PUD Amendment 305 S. Congress “Statesman” (C814-89-0003.02)

Parks and Recreation Board
September 2021

Scott Grantham Principal Planner Parks and Recreation Department

Land Requirements

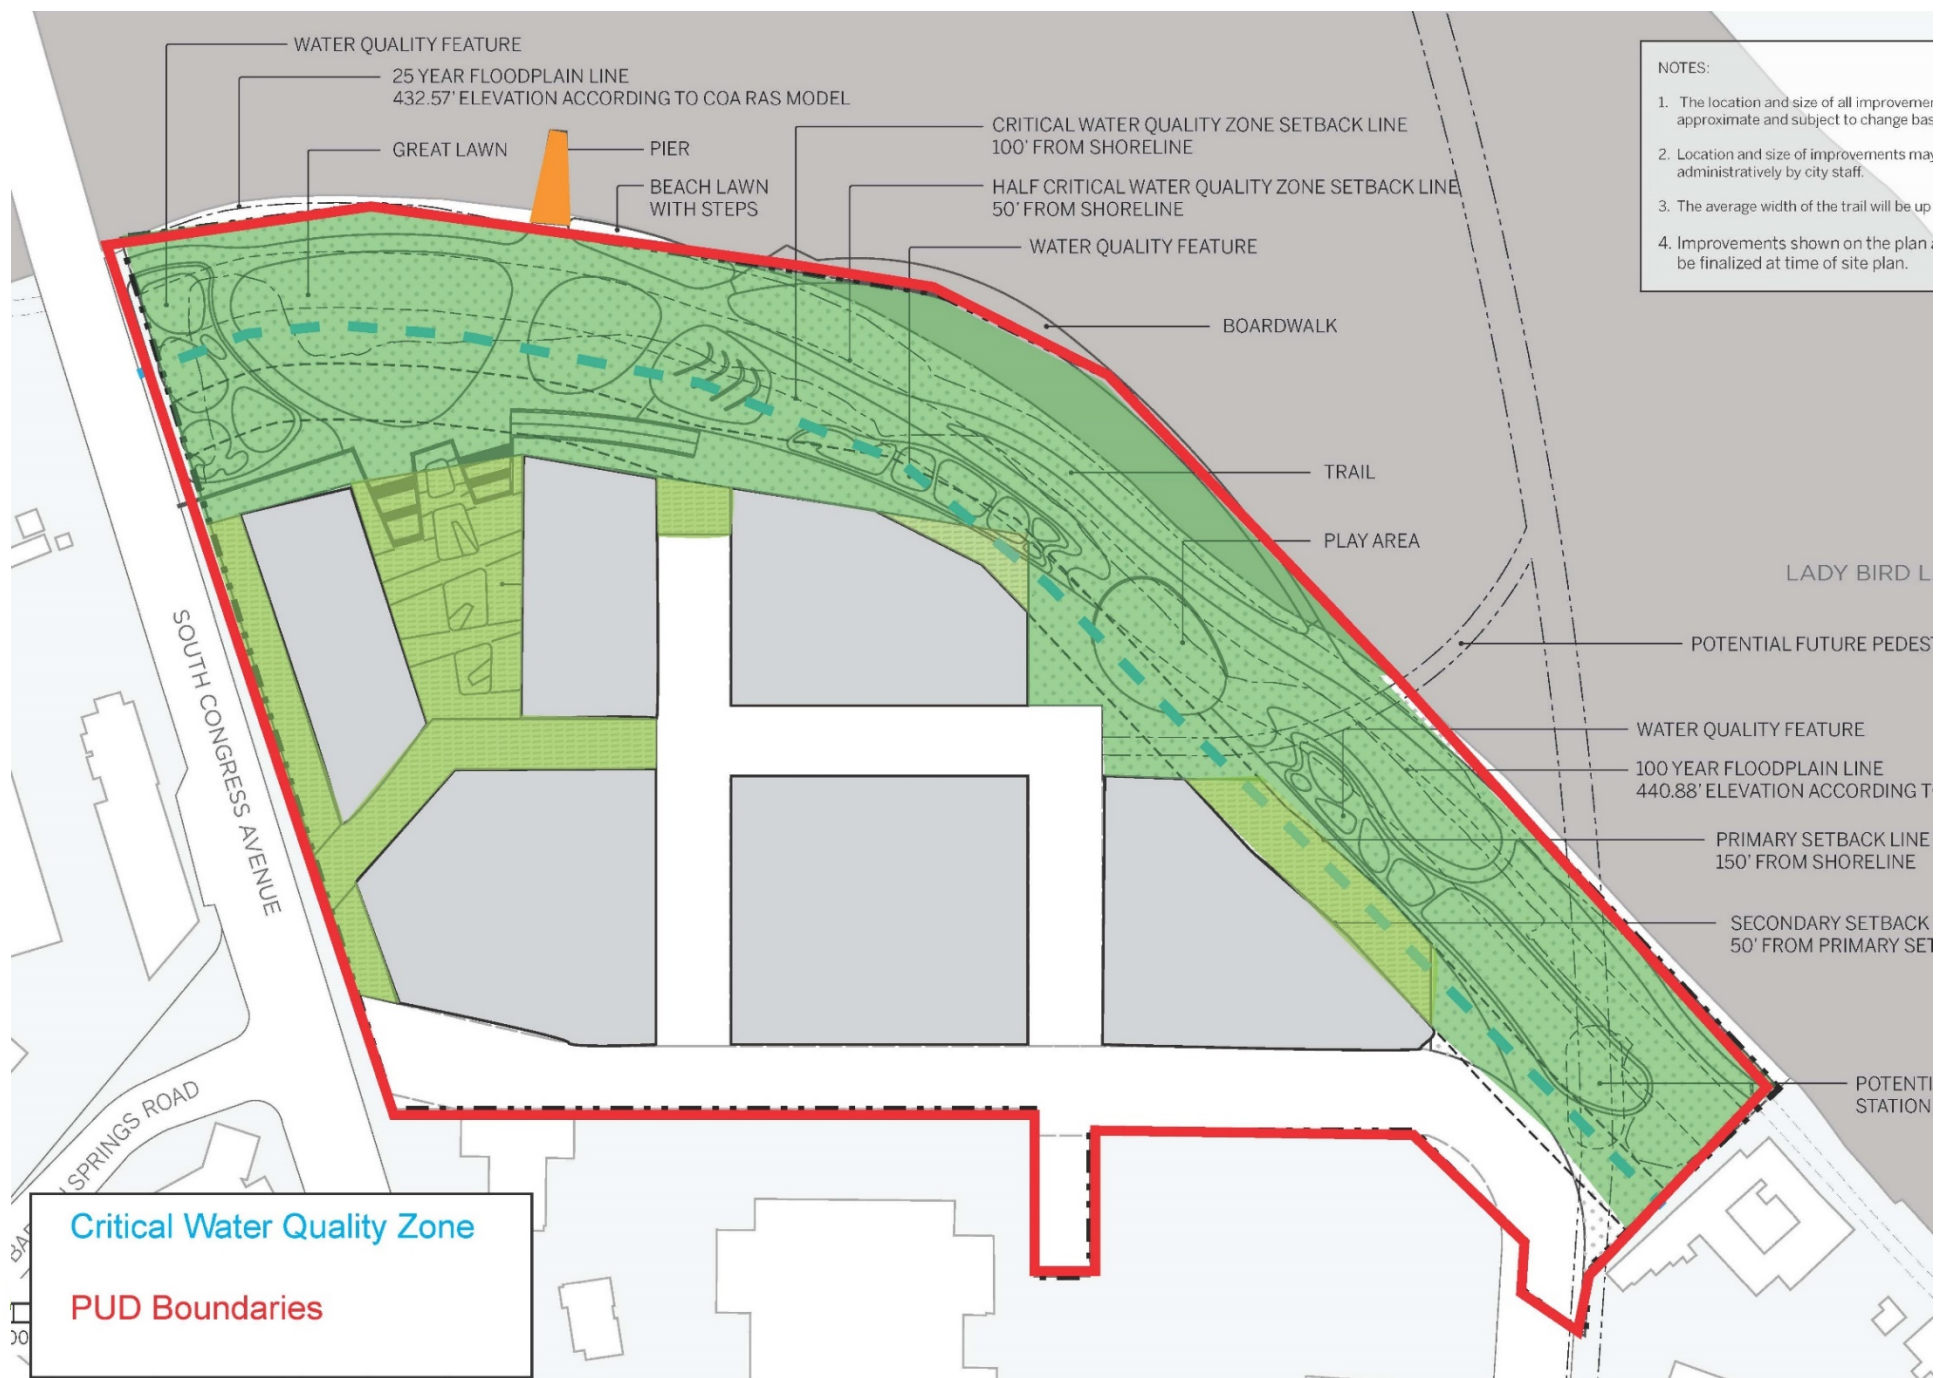
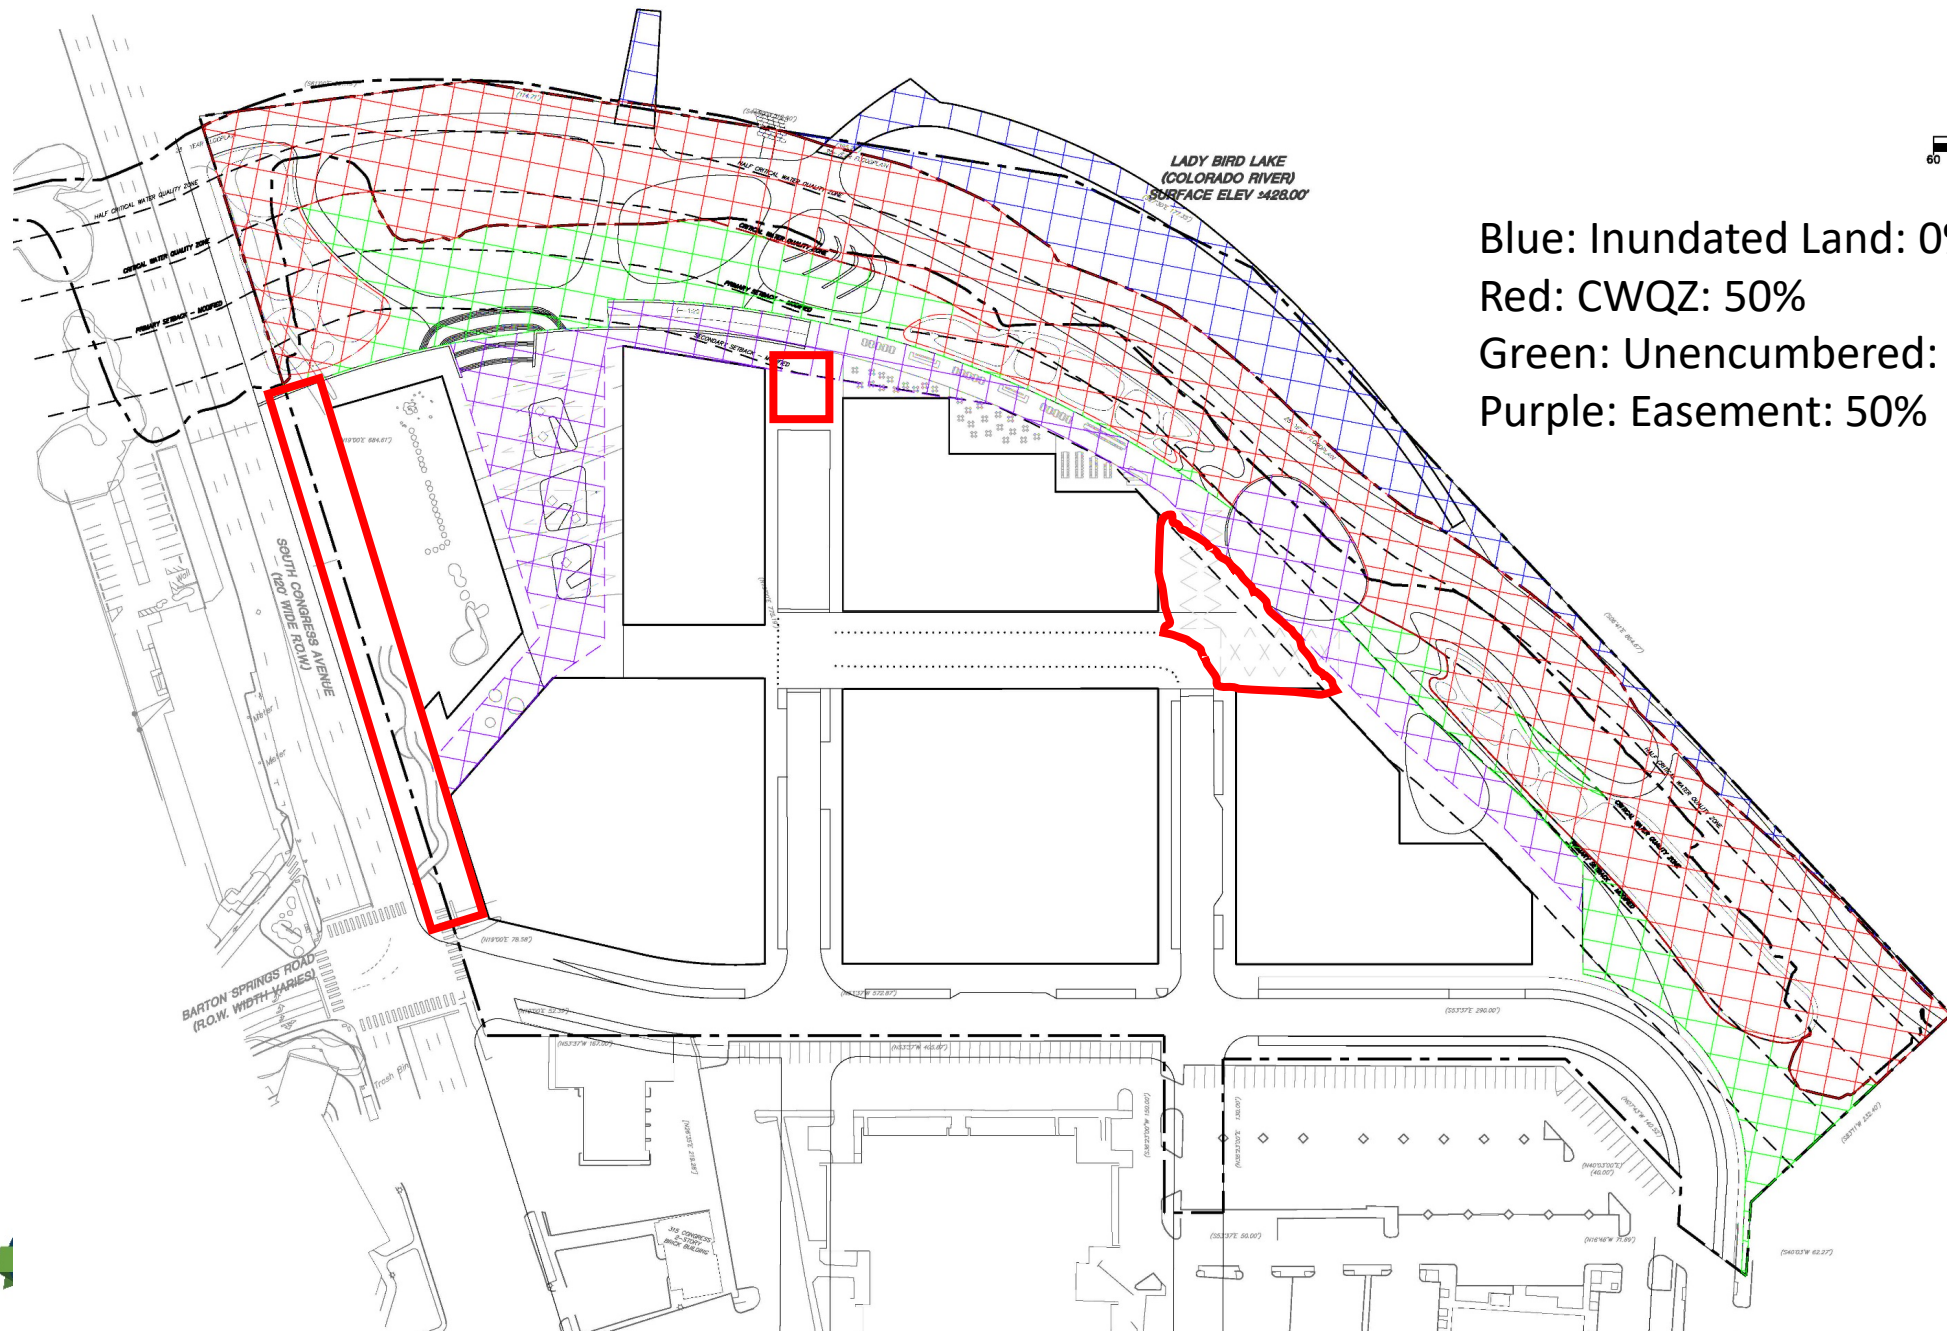
Blue: Inundated Land: 0%
Red: CWQZ: 50%
Green: Unencumbered: 100%
Purple: Easement: 50%

Acres	Factor	Credit
Unencumbered Land (Full Credit)	1.44	1	1.44
Encumbered Land (e.g. CWQZ) (Half Credit)	4.23	0.5	2.12
Inundated Land (Zero Credit)	1.11	0	0
Fully Deeded Land	6.78		3.55
Proposed Easements (Half Credit)	1.59	0.5	0.80
Total (Fully Deeded and Easement)	8.37		4.35
Total Site	18.86		
Gross Percentage	44.4%		
Credited Percentage	23.1%

* Recommend deeded land have no programming conditions written into deed

Water

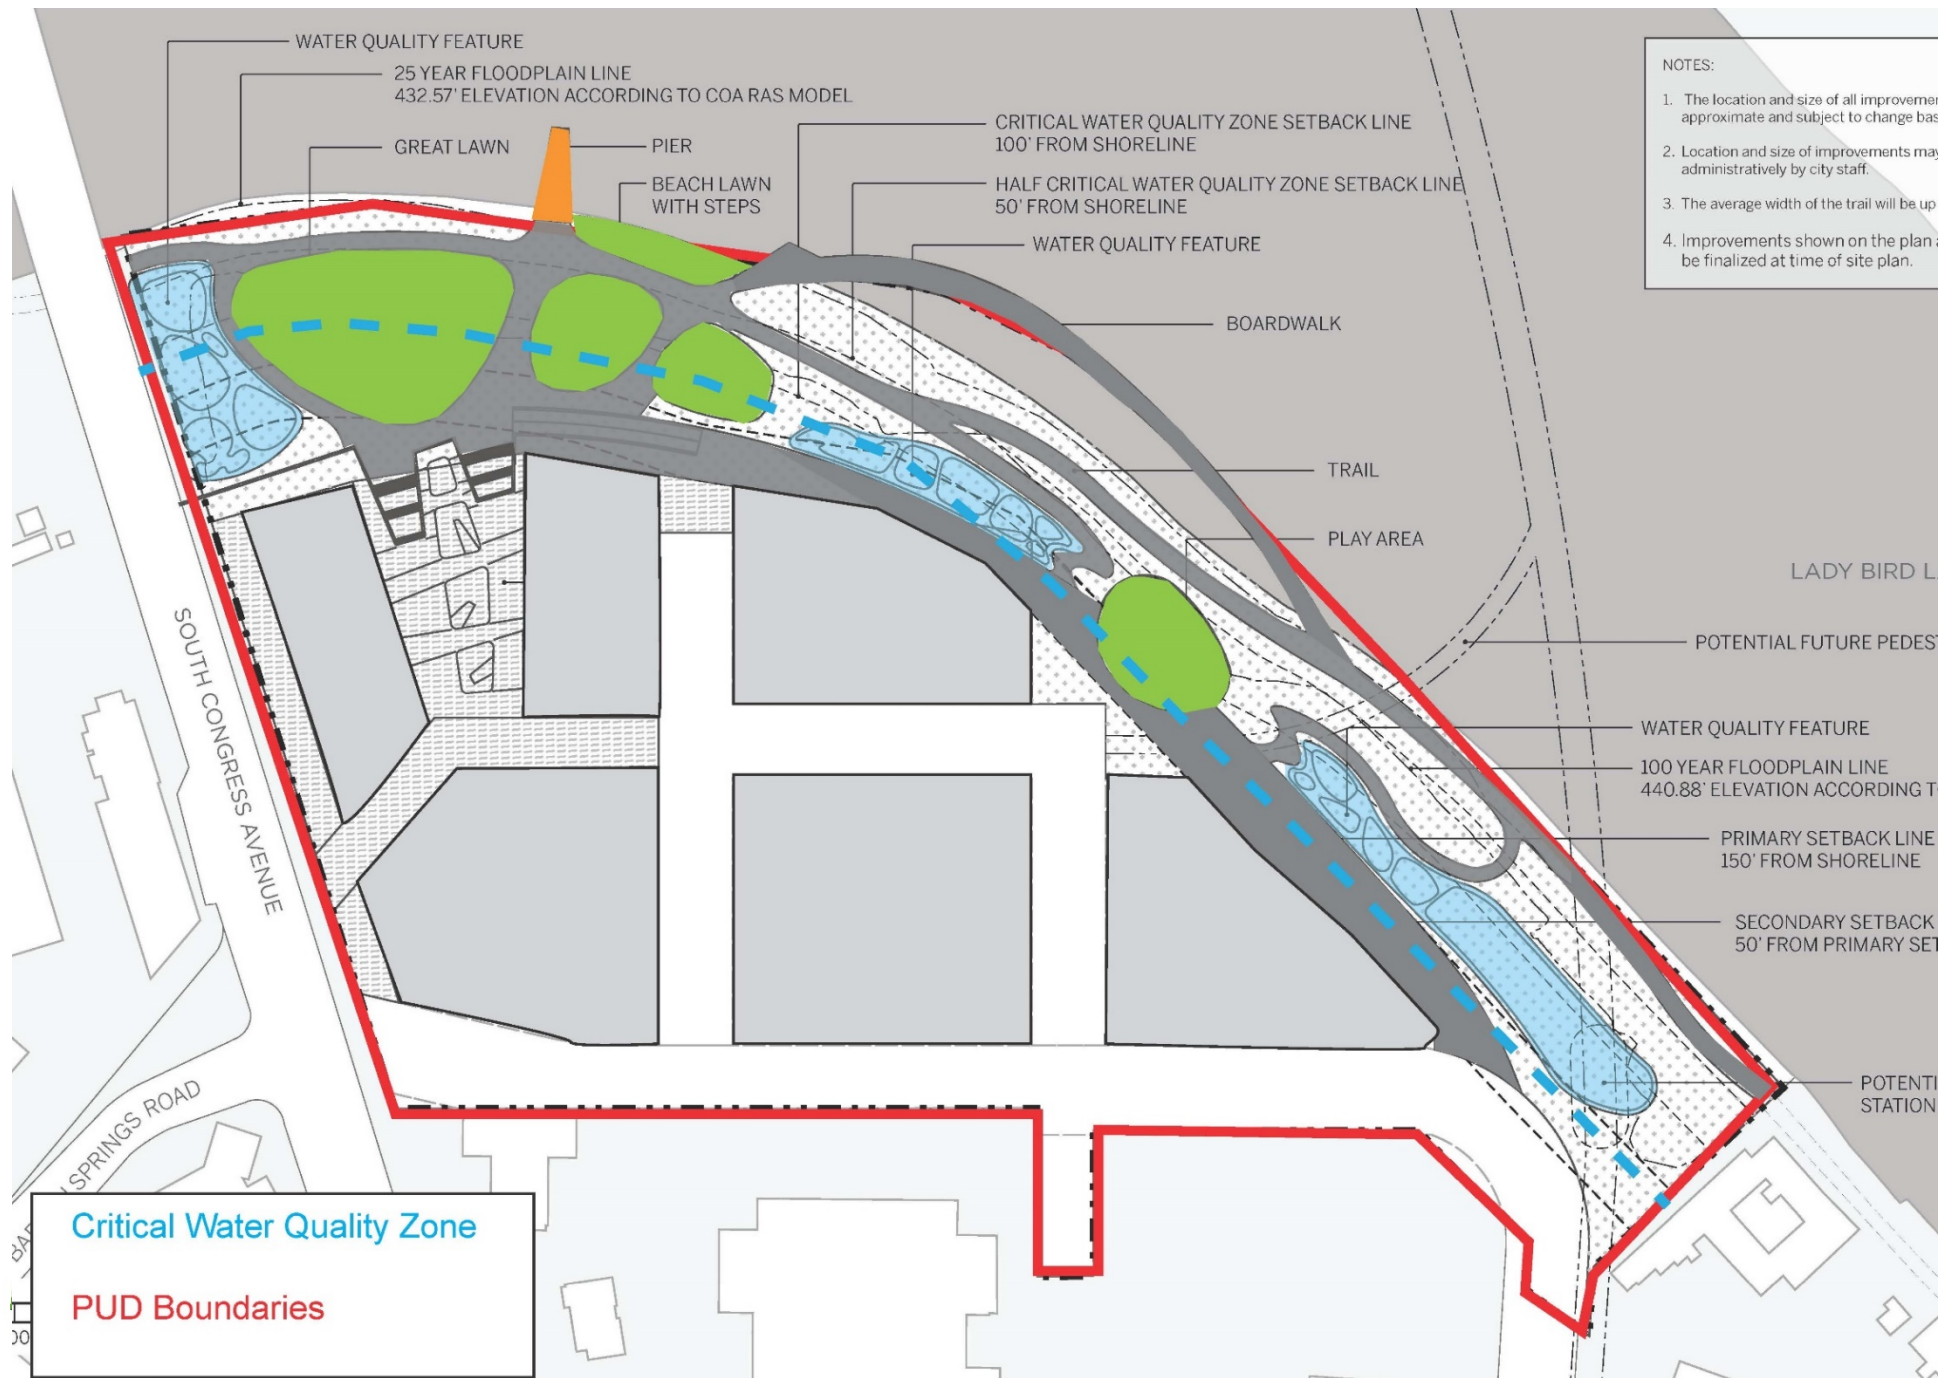
Committed to √ : yes * : partially
Water	
Remove pond from bat viewing area.	*
Demonstrate an amenitized design for ponds and rain gardens within parkland.	*
Include in PUD, cap on square footage of ponds in park area.	√
Land Use	
Remove the following land uses permitted in parkland: Personal Services, Personal Improvement Services, Pet Services.	*
